Title - Sujet Const.Svcs, Westmorland Inst, N.B.	
Solicitation No. - N° de l'invitation EC016-132714/A	Amendment No. - N° modif. 008
Client Reference No. - N° de référence du client R.043939.001	Date 2013-01-25
GETS Reference No. - N° de référence de SEAG PW-\$PWB-020-3192	
File No. - N° de dossier PWB-2-35125 (020)	CCC No./N° CCC - FMS No./N° VME
Solicitation Closes - L'invitation prend fin at - à 02:00 PM on - le 2013-02-06	Time Zone Fuseau horaire Atlantic Standard Time AST
F.O.B. - F.A.B. Plant-Usine: <input type="checkbox"/> Destination: <input type="checkbox"/> Other-Autre: <input type="checkbox"/>	
Address Enquiries to: - Adresser toutes questions à: Donovan, Janine PWB	Buyer Id - Id de l'acheteur pwb020
Telephone No. - N° de téléphone (506) 636-5347 ()	FAX No. - N° de FAX (506) 636-4376
Destination - of Goods, Services, and Construction: Destination - des biens, services et construction:

Addendum No. 8.

QUESTIONS AND ANSWERS

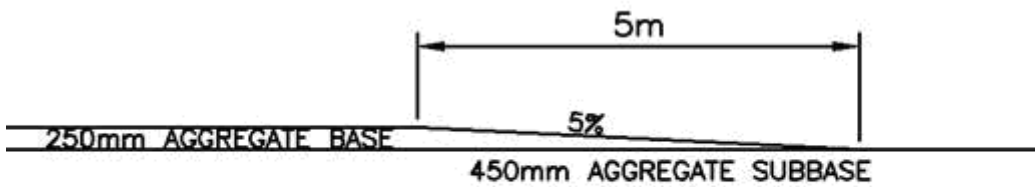
Q1: Drawing C200: There is an area to the South of the new building that does not clearly indicate how the Gravel Yard is built up, there is a space in between two indicated gravel yards at the grade break not clearly indicated if it is to have just the 450mm Sub-base or if it also has the 250mm Aggregate Base at this area in between.

A1: The space in between the two gravel yards is a transition from 250mm of aggregate base to zero. So the section in this area will have 450mm of aggregate subbase and 0-250mm of aggregate base. See Sketch:
